UNITED STATES PATENT AND TRADEMARK OFFICE

Office Action Summary	Application No. 09/970,104	Applicant(s) SUZUKI ET AL.	
	Examiner Raymond Alejandro	Art Unit 1745

DETAILED ACTION

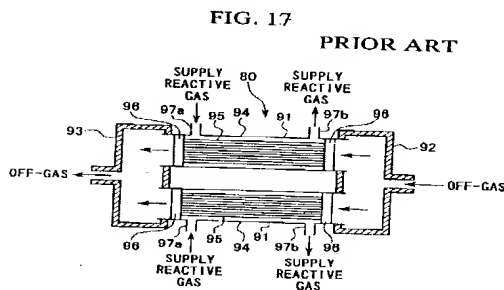
As shown in Figure 17 above, the humidifier has a liquid exhaust mechanism including two supply reactive gas outlets: an upper supply reactive gas outlet 97b and a lower supply reactive gas outlet 97b as indicated by stream flow arrow in Figure 17. Thus, it is noted that the lower supply reactive gas outlet 97b from which humidified supply reactive gas is exhausted is positioned below both the off-gas flow entrance as well as below, at least, an upper supply reactive gas inlet 97a. Thus, the humidifier of Figure 17 satisfies the required functional and structural relationship of the claimed invention.

In view of these disclosures, it would have been obvious to one skilled in the art at the time the invention was made to place the liquid exhaust mechanism of the US patent'261 as taught by the APA'104 as it is known in the art to efficiently remove humidity accumulated inside the humidifying unit by providing a liquid removing feature employing gravity as the driving force. Thus, power consumption associated with the operation of the humidifying unit is reduced, and thus, energy/power is more efficiently used. *Moreover, it has been held that making a feature separable or rearrangement of parts is obvious. Succinctly stated, fact that a claimed a feature of a device/apparatus is made separable or being re-arranged is not sufficient by itself to patentably distinguish over an otherwise old device unless there are new or unexpected results as it is a matter of choice which a person of ordinary skill in the art would have found obvious absent persuasive evidence that the particular configuration of the claimed humidifier was significant. In re Larson 144 USPQ 347, 349. In re Dulberg 129 USPQ 348, 349. In re Stevens 101 USPQ 284. In re Lindberg 93 USPQ 23.*

With respect to the liquid exhaust mechanism being separate from reactive gas exits, it would have been obvious to one skilled in the art at the time the invention was made to separate the liquid exhaust mechanism from the reactive gas exits/off-gas exits of both the US patent'261

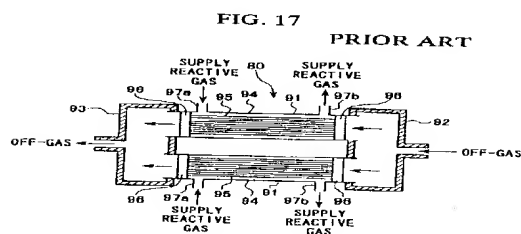
As shown in Figure 17 above, the humidifier has a liquid exhaust mechanism including two supply reactive gas outlets: an upper supply reactive gas outlet 97b and a lower supply reactive gas outlet 97b as indicated by stream flow arrow in Figure 17. Thus, it is noted that the lower supply reactive gas outlet 97b from which humidified supply reactive gas is exhausted is positioned below both the off-gas flow entrance as well as below, at least, an upper supply reactive gas inlet 97a. Thus, the humidifier of Figure 17 satisfies the required functional and structural relationship of the claimed invention.

In view of these disclosures, it would have been obvious to one skilled in the art at the time the invention was made to place the liquid exhaust mechanism of the copending application'277 as taught by the APA'104 as it is known in the art to efficiently remove humidity accumulated inside the humidifying unit by providing a liquid removing feature employing gravity as the driving force. Thus, power consumption associated with the operation of the humidifying unit is reduced, and thus, energy/power is more efficiently used. Moreover, it has

With respect to the liquid exhaust mechanism being separate from reactive gas exits, it would have been obvious to one skilled in the art at the time the invention was made to separate the liquid exhaust mechanism from the reactive gas exits/off-gas exits of both the copending application'277 and the APA'104 because it has been held that making a device/feature either integral and/or separable is obvious. Succinctly stated, fact that a claimed device/apparatus/element is made separable, integral or adjustable is not sufficient by itself to patentably distinguish over an otherwise old device unless there are new or unexpected results as it is a matter of choice which a person of ordinary skill in the art would have found obvious absent persuasive evidence that the particular configuration of the claimed humidifier was significant. In re Larson 144 USPQ 347, 349. In re Dulberg 129 USPQ 348, 349. In re Stevens 101 USPQ 284. In re Lindberg 93 USPQ 23. ***(See MPEP 2144.04 [R-1] Legal Precedent as Source of Supporting Rationale: V. Making Portable, Integral, Separable, Adjustable, or Continuous).***

FIG. 17

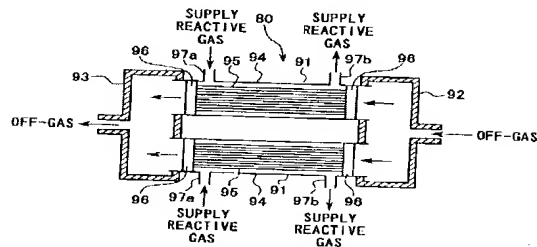
As shown in Figure 17 above, the humidifier has a liquid exhaust mechanism including two supply reactive gas outlets: an upper supply reactive gas outlet 97b and a lower supply reactive gas outlet 97b as indicated by stream flow arrow in Figure 17. Thus, it is noted that the lower supply reactive gas outlet 97b from which humidified supply reactive gas is exhausted is positioned below both the off-gas flow entrance as well as below, at least, an upper supply reactive gas inlet 97a. Thus, the humidifier of Figure 17 satisfies the required functional and structural relationship of the claimed invention.

The APA'104 discloses a humidifier for a fuel cell according to the foregoing aspects. However, the APA'104 does not expressly disclose the liquid exhaust mechanism being separate from the reactive gas exits.

In view of the above, it would have been obvious to one skilled in the art at the time the invention was made to separate the liquid exhaust mechanism from the reactive gas exits/off-gas exits of the APA'104 because it has been held that making a device/feature either integral and/or separable is obvious. Succinctly stated, fact that a claimed device/apparatus/element is made separable, integral or adjustable is not sufficient by itself to patentably distinguish over an otherwise old device unless there are new or unexpected results as it is a matter of choice which a person of ordinary skill in the art would have found obvious absent persuasive evidence that the particular configuration of the claimed humidifier was significant. In re Larson 144 USPQ 347, 349. In re Dulberg 129 USPQ 348, 349. In re Stevens 101 USPQ 284. In re Lindberg 93 USPQ 23. (*See MPEP 2144.04 [R-1] Legal Precedent as Source of Supporting Rationale:V. Making Portable, Integral, Separable, Adjustable, or Continuous*).
